49 Miller Street Block 54, Lot 7.01

Re: 49 Miller Street, LDN Real Estate, LLC Block 54, Lot 7.01 Review of Major Subdivision, Plat Requirements (completeness) CBD Zone

Re: 49 Miller Street – LDN Real Estate, LLC Block 54, Lot 7.01 Major Subdivision and Use Variance First Engineering Review

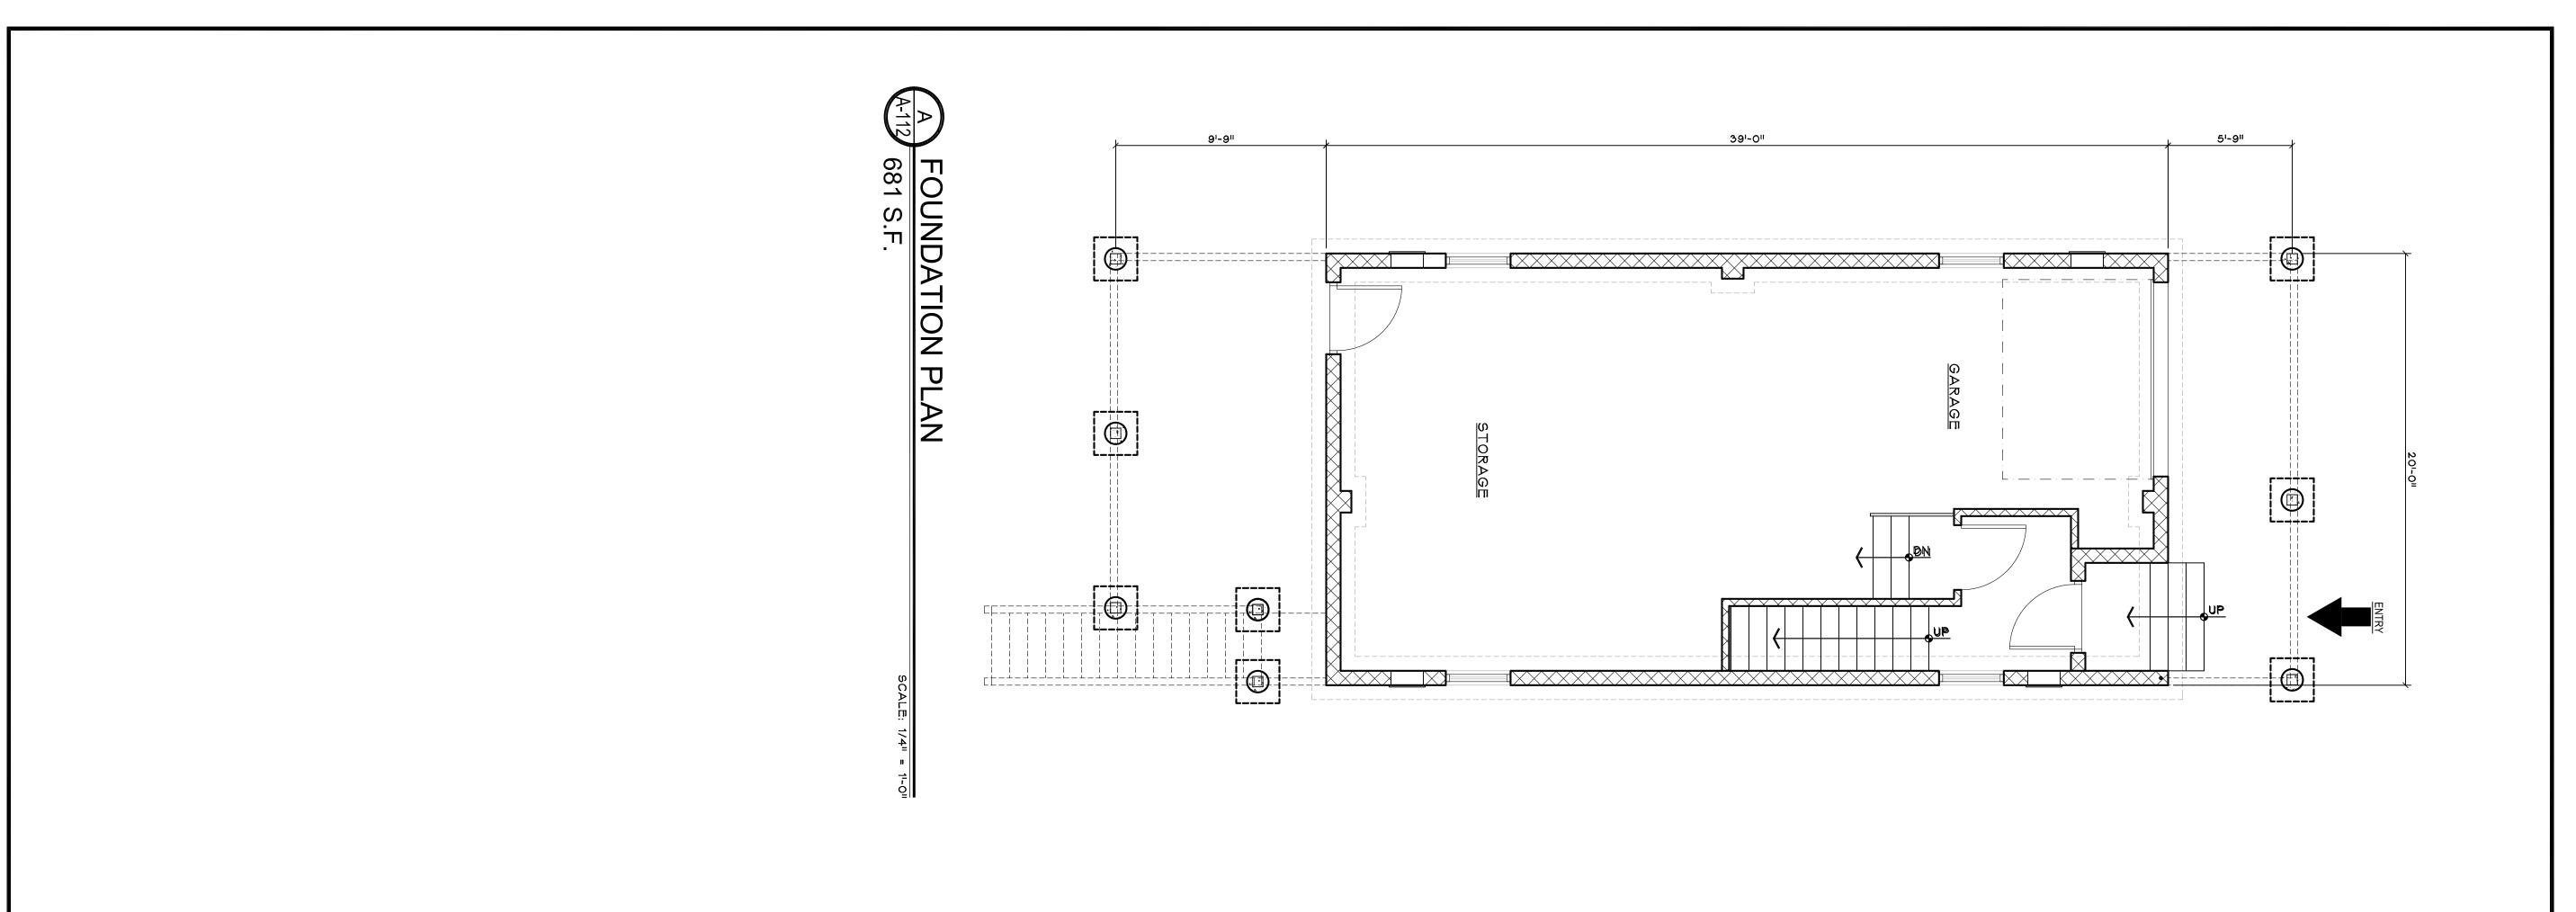
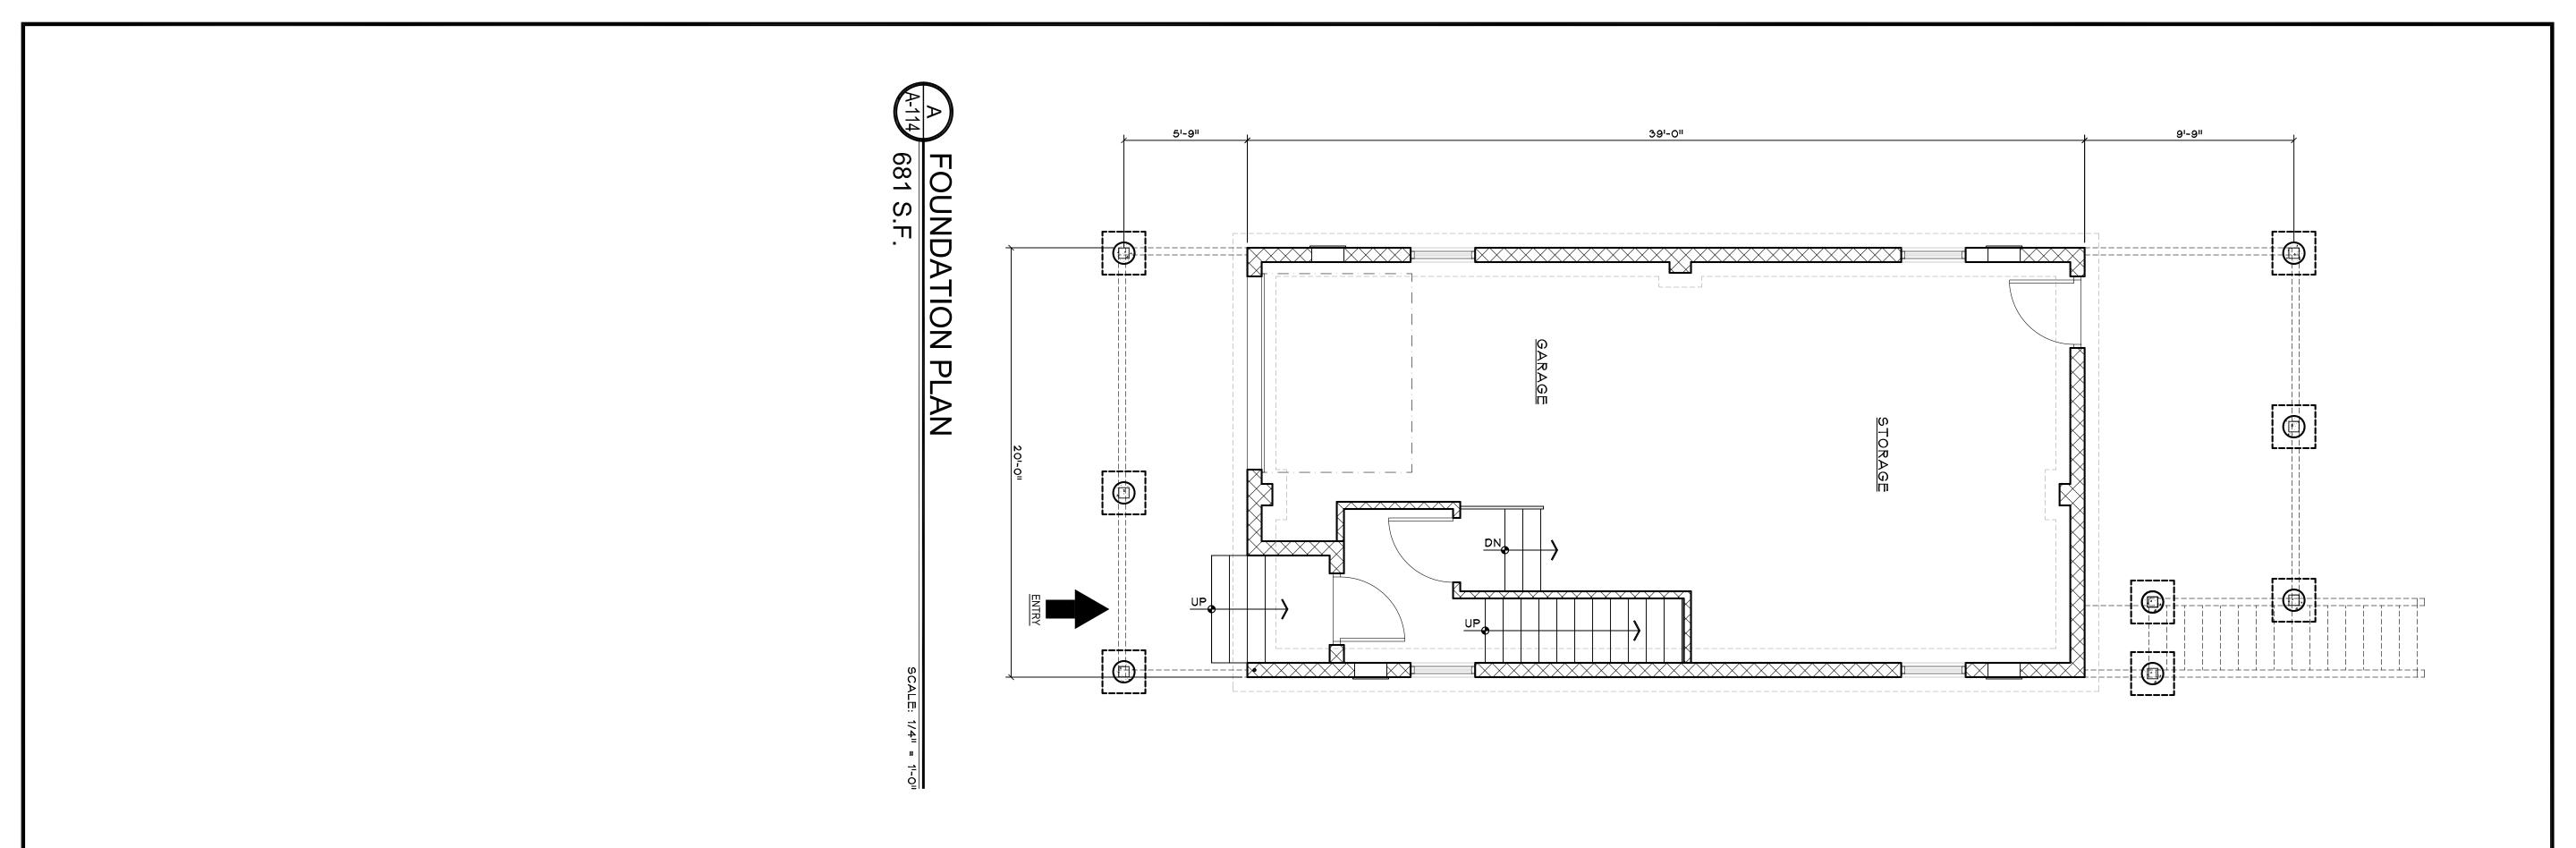
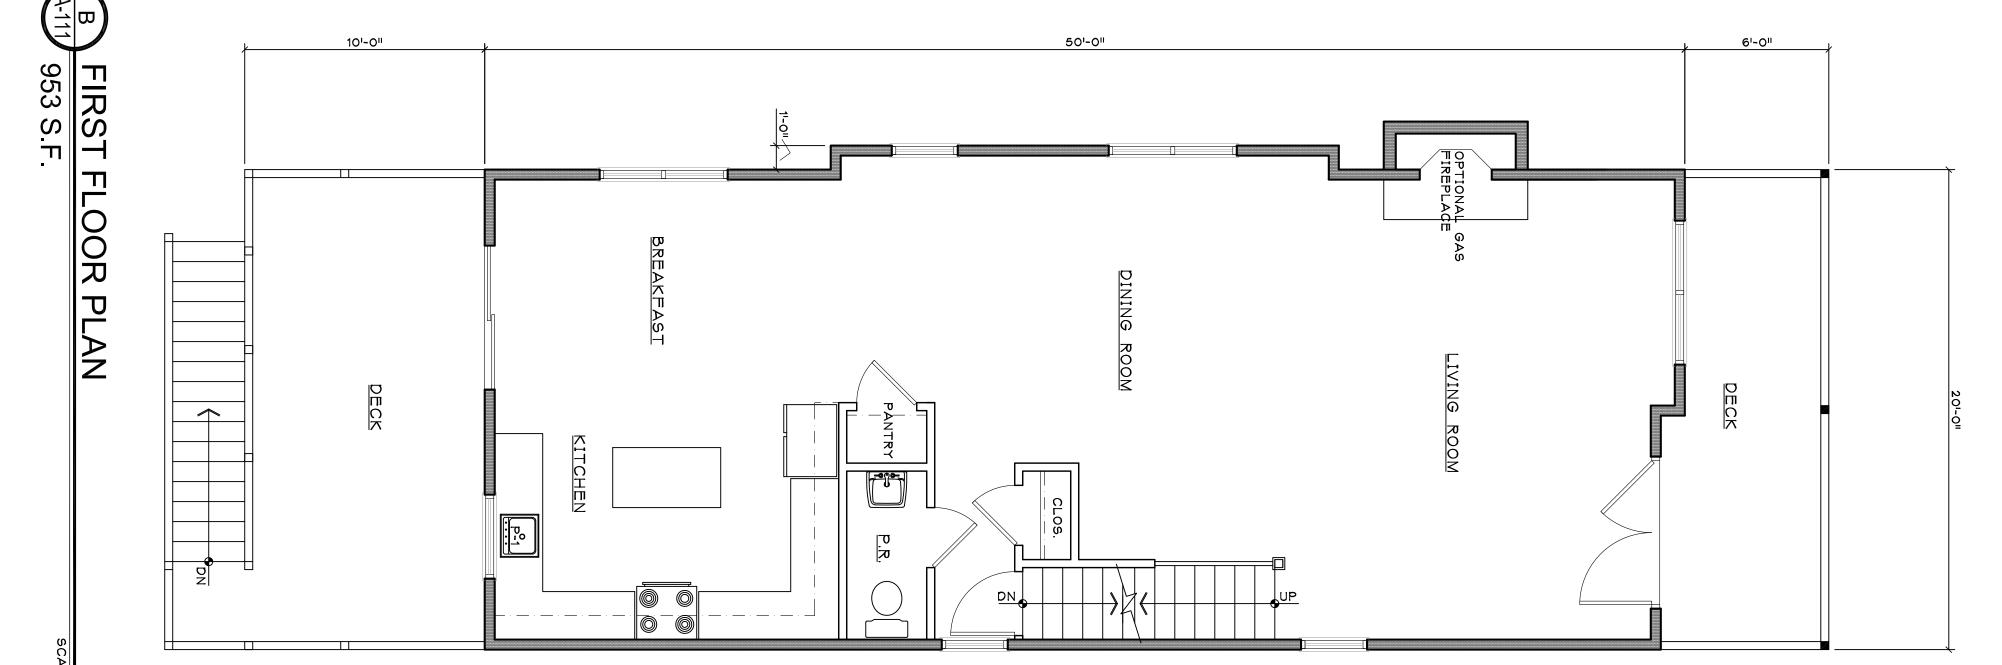
1. It should be noted that this property is located within the "AE" flood zone with a Base Flood Elevation (BFE) of 11 feet. The applicant shall confirm the elevations on the individual architectural plans. Additionally, it is recommended that the applicant obtain an Elevation Certificate for the subject property.

- 4. The Building Department should review the architectural plans for ADA compliance.
- 5. The applicant will ultimately be obligated to comply with the Borough's Affordable Housing obligations/requirements.

- 8. The applicant should be aware that construction of habitable space below the base flood elevation could subject this space to inundation by floodwaters. This construction could also have an impact on the applicant's future flood insurance premiums. The applicant should clarify any/all uses of ground floor area.
- 9. Should this application ultimately secure Board approval, a plat consistent with the State's Title Recordation Act will be required.
- 10. Approvals or waivers should be obtained from any agencies having jurisdiction. These may include, but shall not be limited to, the following:
 - a. Monmouth County Planning Board
 - b. Freehold Soil Conservation District
 - c. New Jersey Department of Environmental Protection
 - d. Construction Office
 - e. DPU/DPW
 - f. Fire Official

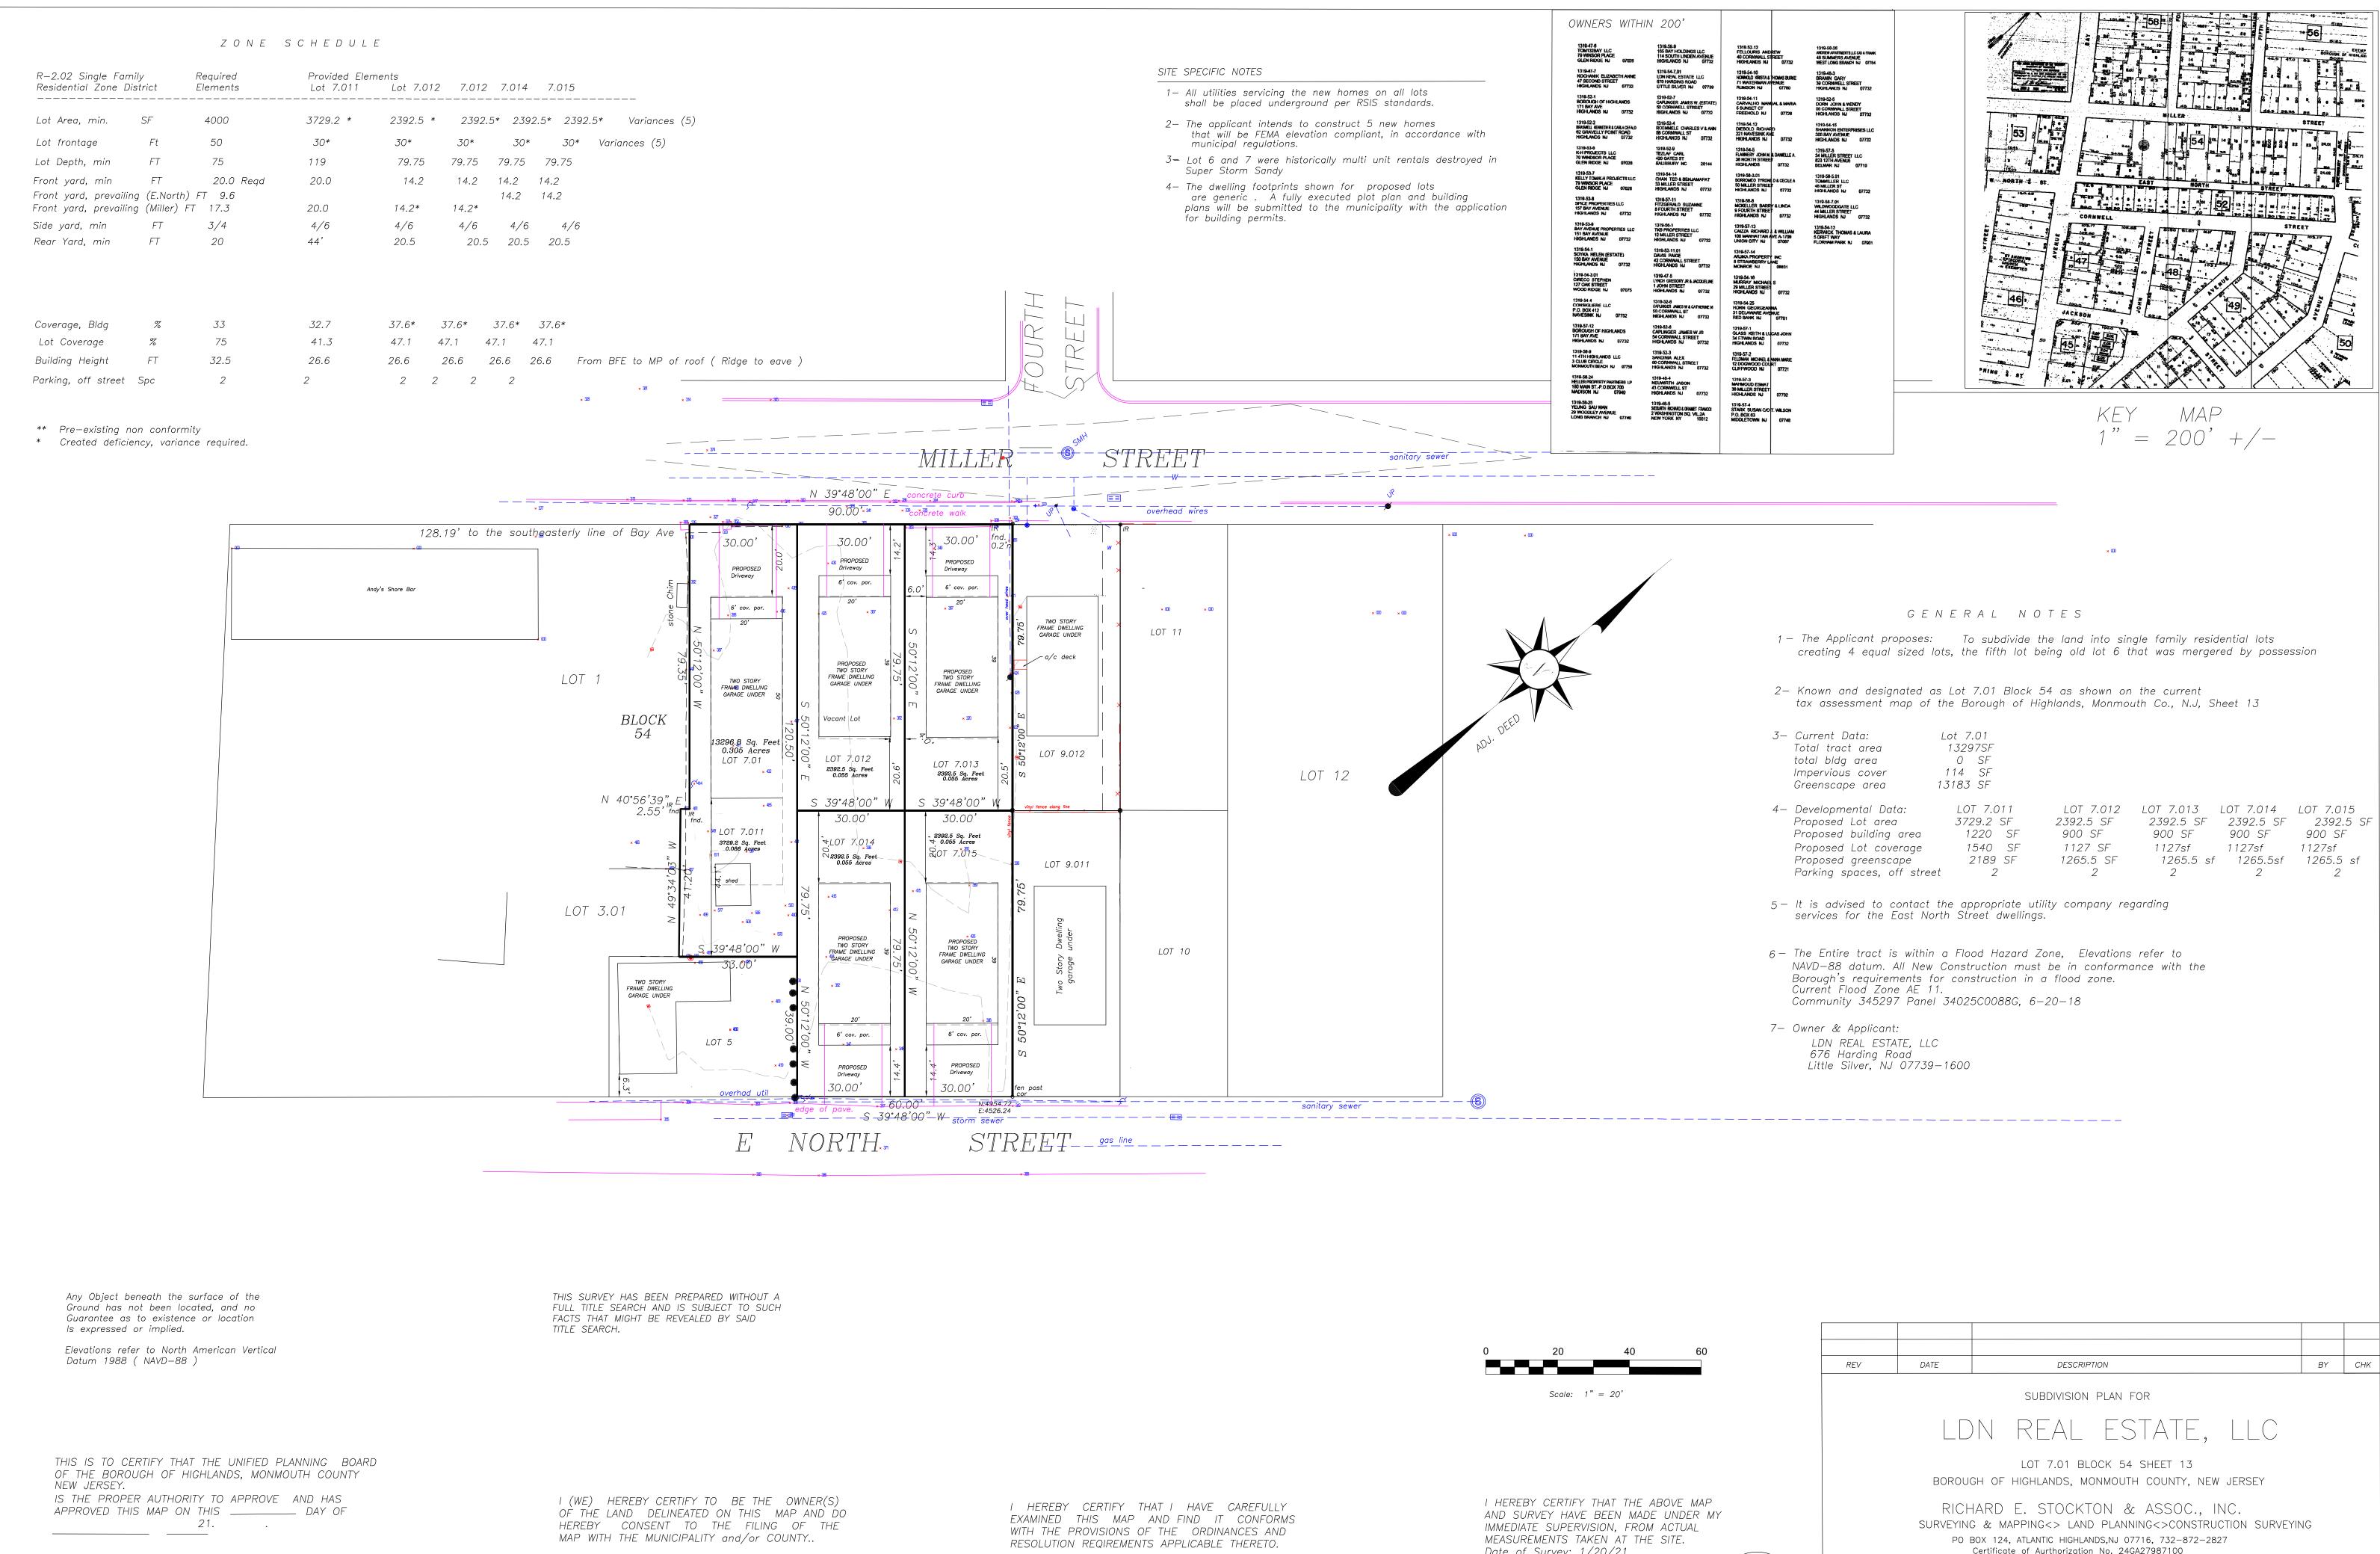
- 3. The Cover Sheet shall be revised to indicate that the property is located in the CBD Zone.
- 4. The proposed application will ultimately require the bulk 'c' variances noted in the chart above if reviewed under the R-2.02 standards.

- 1. The applicant is seeking a total of five building lots. Given the dual roadway frontage, each proposed lot will have frontage and access to a municipal street. No new roadways are proposed.

- 2. The applicant is proposing a one-car garage and driveway combination for each unit, yielding at least two (2) off-street parking spaces per dwelling, which is consistent with the RSIS standards for three-bedroom units. The four-bedroom unit (lot 7.011) would require 2.5 parking spaces. The applicant shall provide testimony on the adequacy of the proposed number of parking spaces for this unit, considering the driveway width and length.

- 3. The limits of all proposed curb, sidewalk, and asphalt shall be clearly shown on the plans. There is existing curb and sidewalk along Miller Street that will need to be adjusted. There is no curb or sidewalk along East North Street along the frontage of this property. The Board should determine if adding curb and sidewalk there would be appropriate.

- 6. Detailed plot/grading/stormwater management plans should be provided.

- 1. Per Ordinance Section 21-65.10.A, all areas not devoted to structures, paving, or other required uses shall be appropriately graded, landscaped, and maintained in accordance with a landscaping plan approved by the Board. No landscaping has been provided.
- 2. We recommend street trees be provided as required under Ordinance Section 21-65.10.B.
- 3. No landscaping is proposed around the proposed buildings and throughout the site. We recommend additional shrubs and tree plantings be provided, along with increasing the diversity of plant species to avoid the hazards of monoculture and enhance visual interest.
- 4. No lighting is indicated on the plans. The applicant should provide testimony on their lighting intent.
